CMB Meeting Minutes #178

SUBJECT: Configuration Management Board Meeting # 178 – Rev. No. 0

Project No. M544.1, Contract No. CS-149
Program/Construction Management
Configuration Management Board (CMB) Meeting No. 178
July 16, 2014
3:00pm – 5:00pm
Central Subway Project Office
821 Howard St. 2nd Floor
Main Conference Room

\\sv6nos003.muni.sfgov.org\m544.1\finaldesign\drawing-821\3-structural\building protection\sheet files op03\M54423BP107.dwg lmculty Thu Jan 27, 2011 - 1:06 pm BP-107

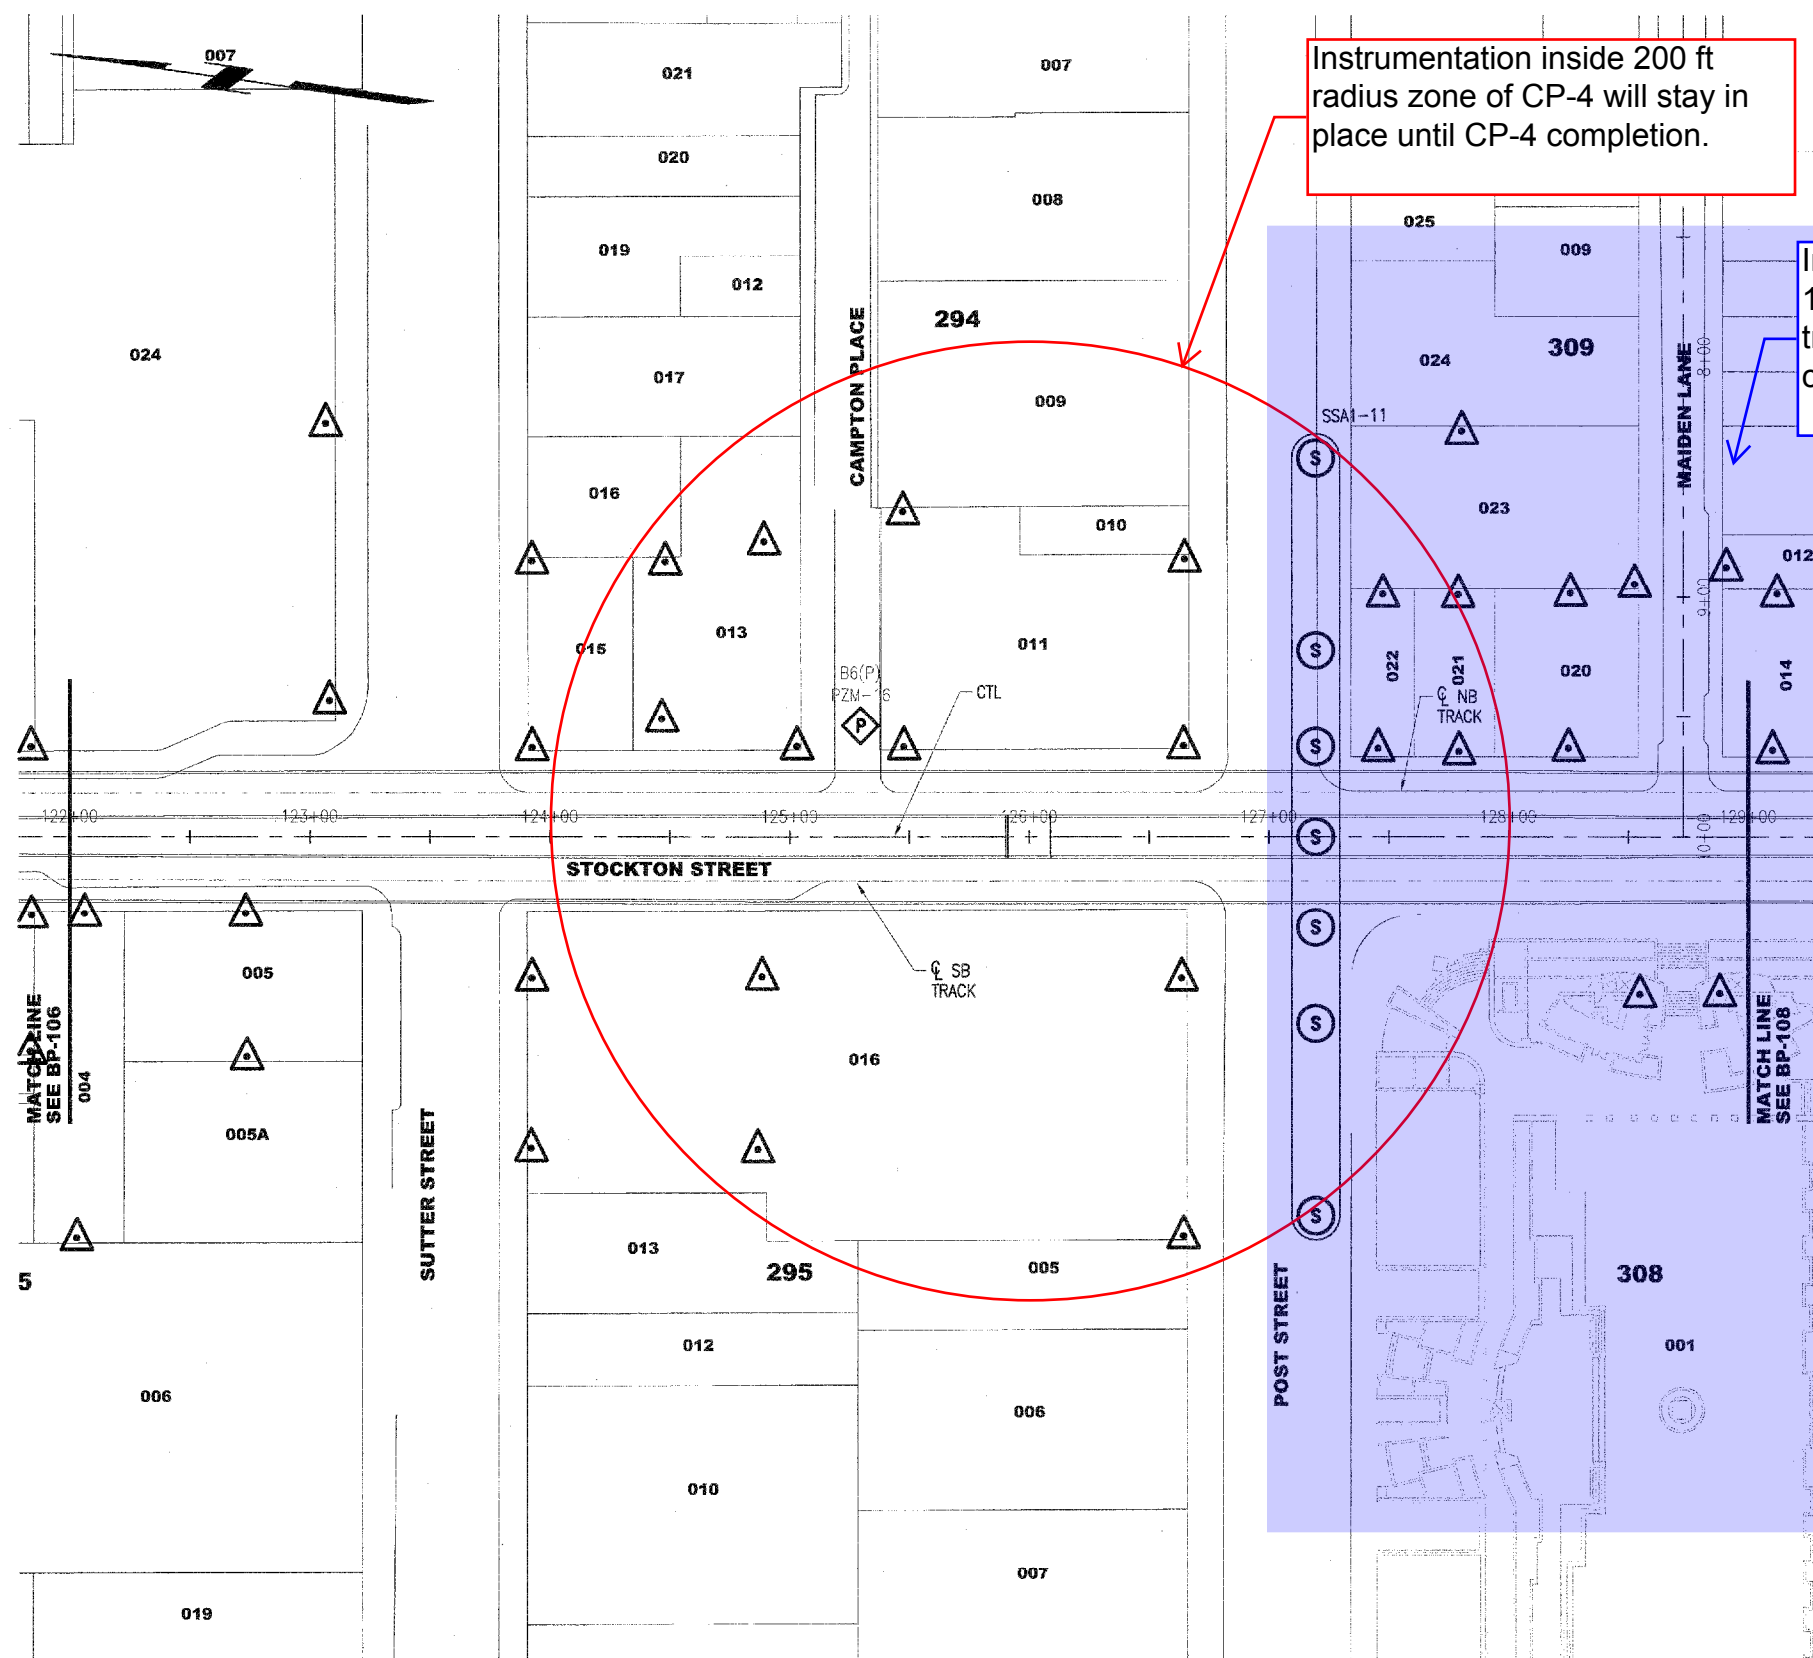
The attached marked-up contract drawing (BP-107) shows a red circle representing an area extending 200 feet from the center of Cross Passage 4 (CP-4) which will continue to be monitored until completion of the CP-4 work. Instruments shown on attached contract drawing BP-107 not included in the red circle (CP-4 area) or the blue area (UMS turnover area) are requested to be abandoned and area restored per the Contract documents.

CONTRACT NO.	1252
SPMTA CONTROL NO.	CL-18479
DRAWING NO.	BP-109
SHEET NO.	490
REVISION	0

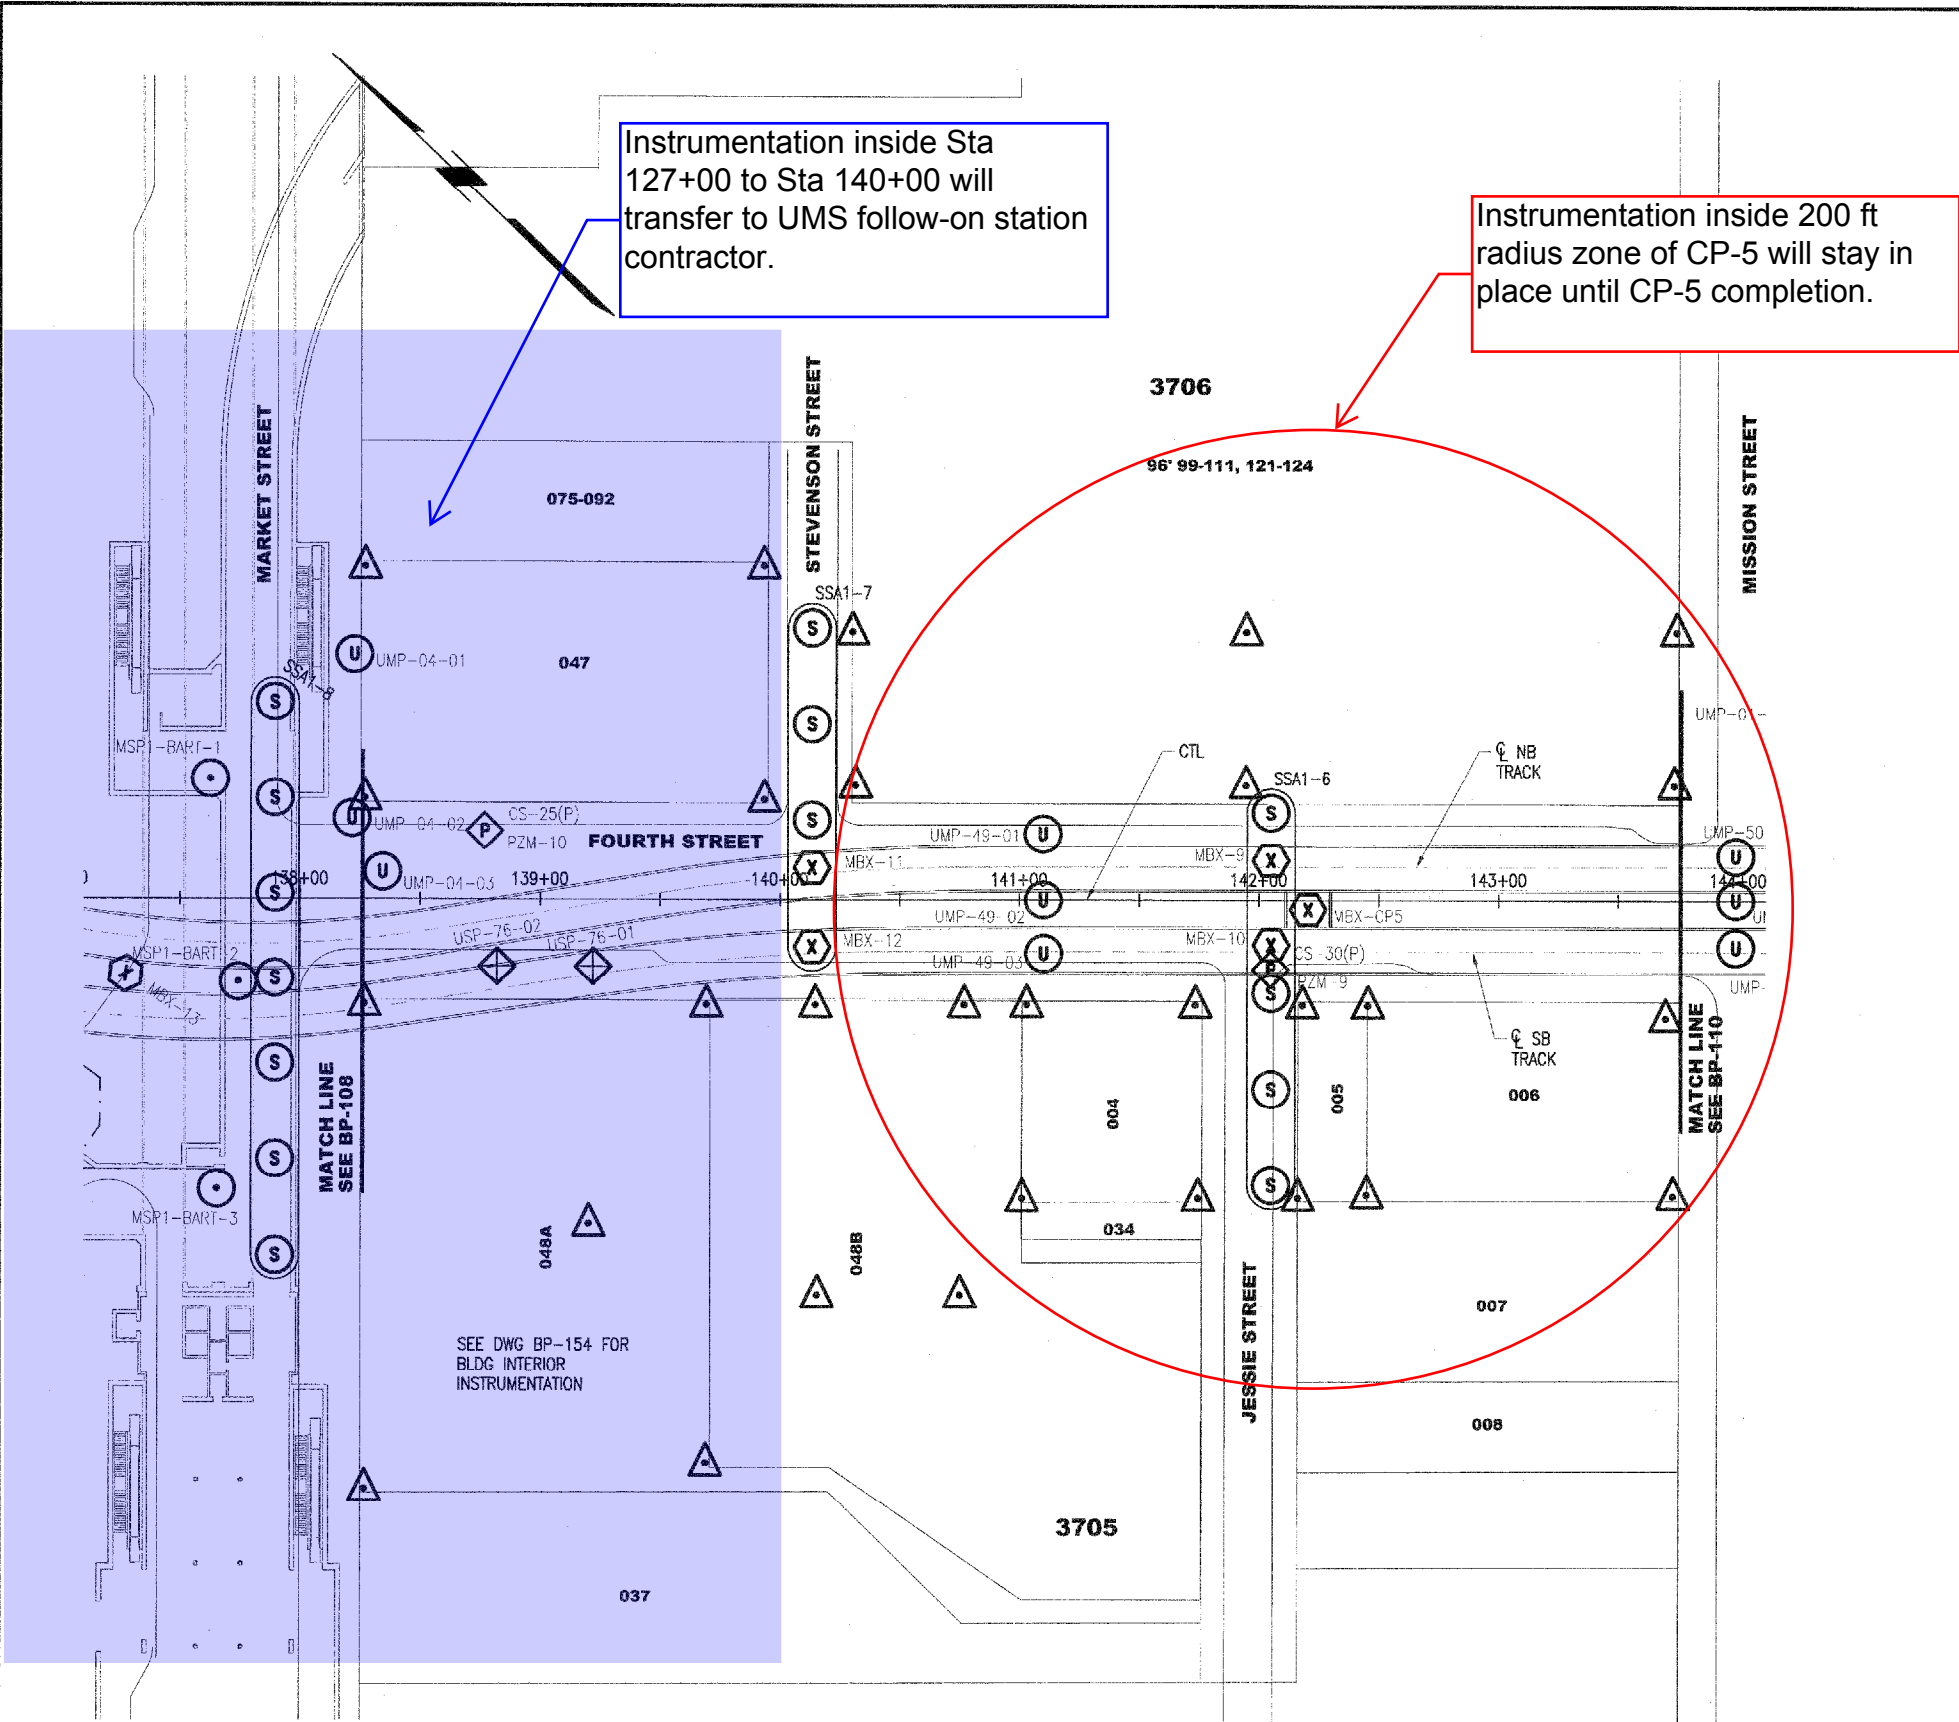
The attached marked-up contract drawing (BP-109) shows a red circle representing an area extending 200 feet from the center of Cross Passage 5 (CP-5) which will continue to be monitored until completion of the CP-5 work. Instruments shown on attached contract drawing BP-109 not included in the red circle (CP-5 area) or the blue area (UMS turnover area) are requested to be abandoned and area restored per the Contract documents.

Instrumentation inside Sta 127+00 to Sta 140+00 will transfer to UMS follow-on station contractor.

CONTRACT NO.	1252
SFMTA CONTROL NO.	CL-18480
DRAWING NO.	BP-110
SHEET NO.	491
REVISION	0

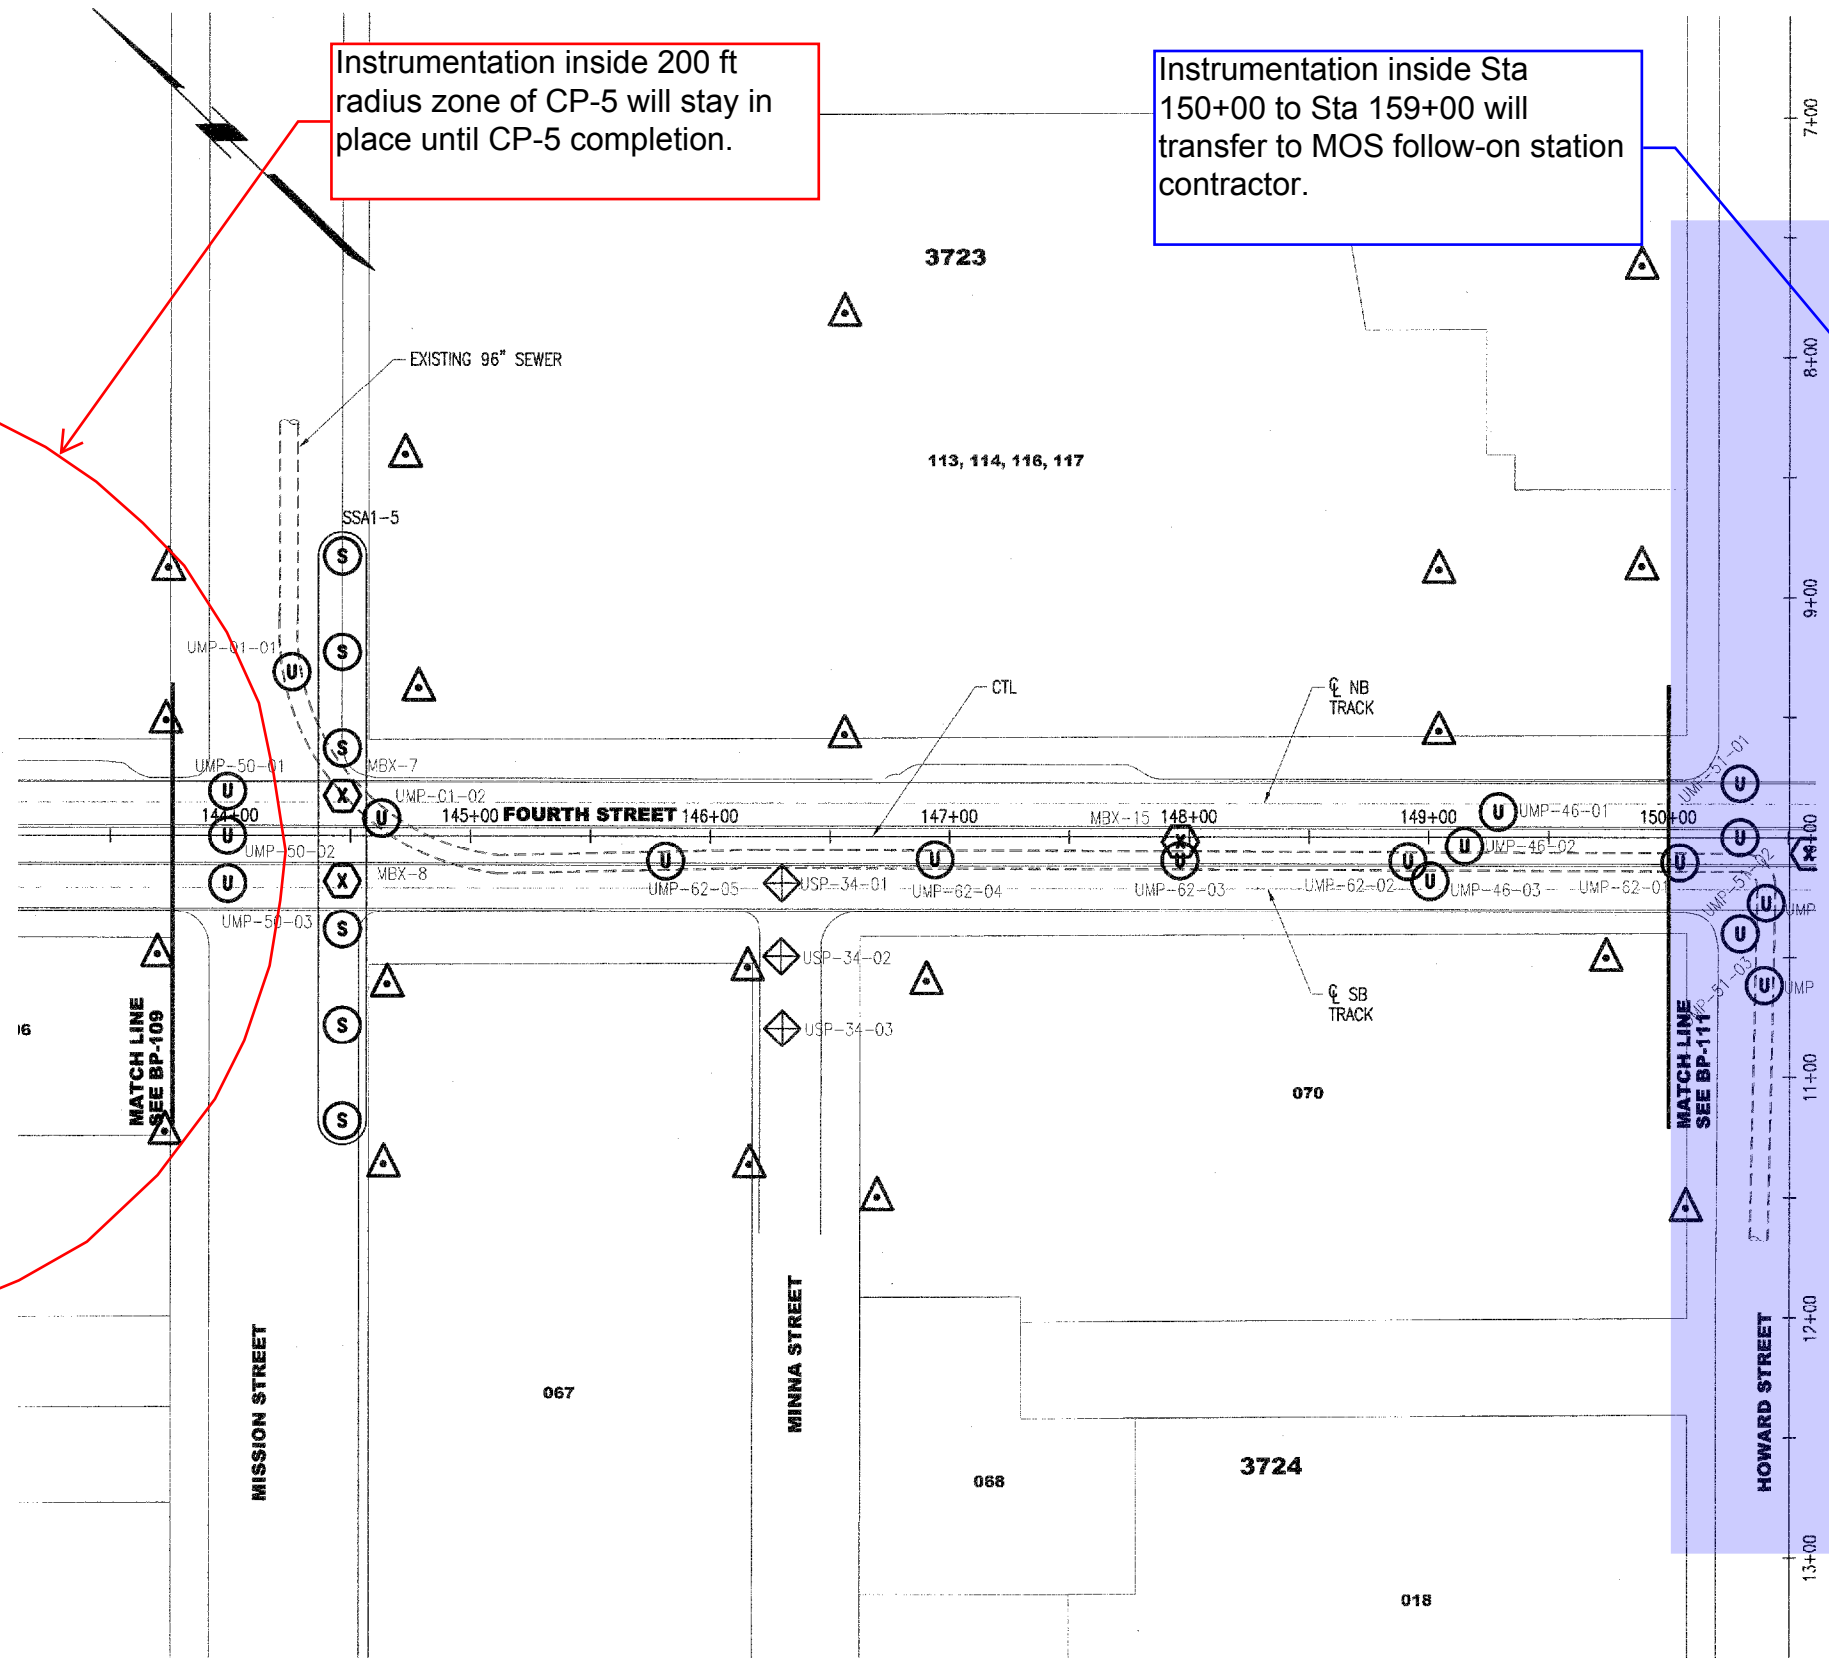
The attached marked-up contract drawing (BP-110) shows a red circle representing an area extending 200 feet from the center of Cross Passage 5 (CP-5) which will continue to be monitored until completion of the CP-5 work. Instruments shown on attached contract drawing BP-110 not included in the red circle

Instrumentation inside 200 ft radius zone of CP-5 will stay in place until CP-5 completion.

Instrumentation inside Sta 150+00 to Sta 159+00 will transfer to MOS follow-on station contractor.
